(Excerpts from Florence Realization 2020 Comprehensive Plan Soils and Hazards Maps)

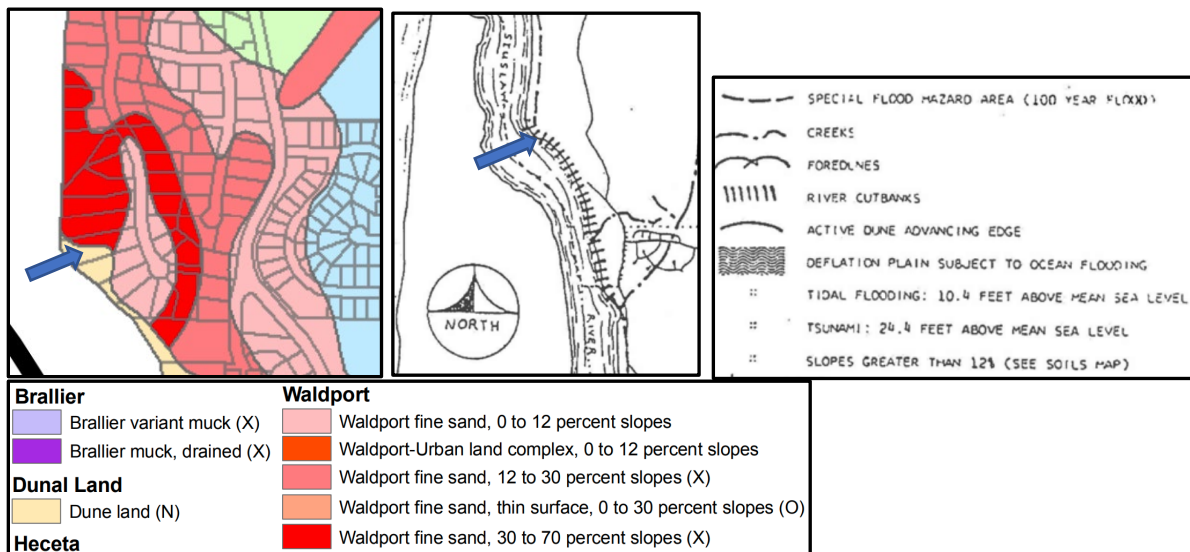
The adopted Soils Map illustrates Dune land, Waldport fine sand with 30 to 70% slopes and Waldport fine sand with 0 to 12% slopes on the subject site. The site is also located adjacent to a river cutbank on the Hazards Map. To identify the exact location of the cutbank and actual

presence of soils and their locations a Phase I Site Investigation Report (SIR) was required. The application did include a site plan illustrating a 50' setback line. The label states it is the top of bank. However, it does not follow the contour for top of bank but rather is a somewhat straight line aligned on the top most north-south oriented contour line. It is there where the 50' is met but where the contours wrap eastward on the south side of the lot the home is setback at most 20' from top of bank. The 50' top of bank setback from a cutbank is not met. Their home foundation is proposed to be engineered.
